Subject: Governmental Facilities Hearing Application GF07-08 Model Cities Fire Rescue Station No. 2 for the Fire Rescue Department

Memorandum

Subject: Governmental Facilities Hearing Application GF07-08 Model Cities Fire Rescue Station No. 2 for the Fire Rescue Department

APPLICATION GF07-08

Site Plan

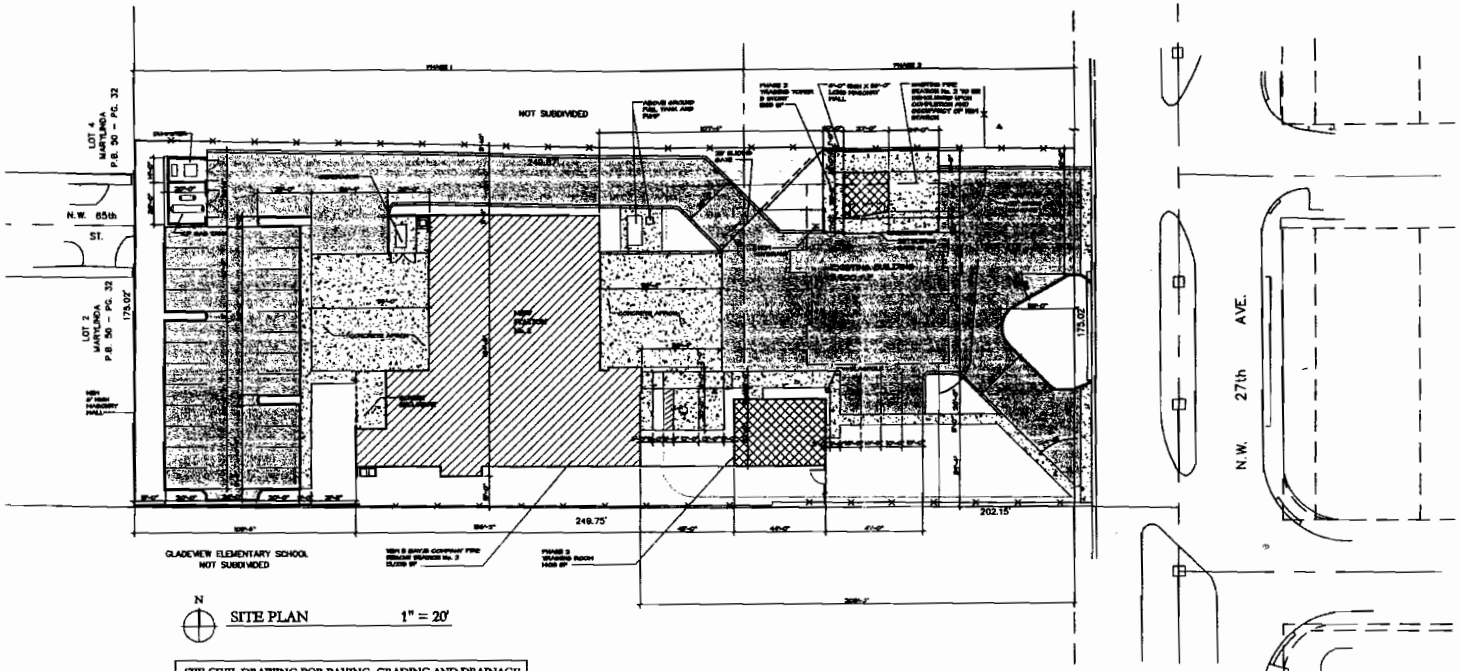
2. That in the approval of the plan, the same be basically in accordance with the plan submitted for the hearing entitled, "Model Cities Fire Rescue Station No. 2", prepared by Landera Associates, P.A., dated May 1, 2008 consisting of 13 pages, except as modified herein to provide the 21' wide landscaped buffer along the rear (west) property line.

4. That the landscaped buffer along the rear (west) property line be increased from 15' to 21' and that a double row of either Live Oak or Mahogany trees with a maximum height of 10' to 12' at the time of planting, spaced 25' on center, be provided within the buffer area along the rear west property line.

Reduce the employee parking paved asphalt area to the minimum required by code or replace the asphalt employee parking lot with grass pavers in order to provide a more open/percolation landscape area and reduce the impact to the adjacent residential properties.
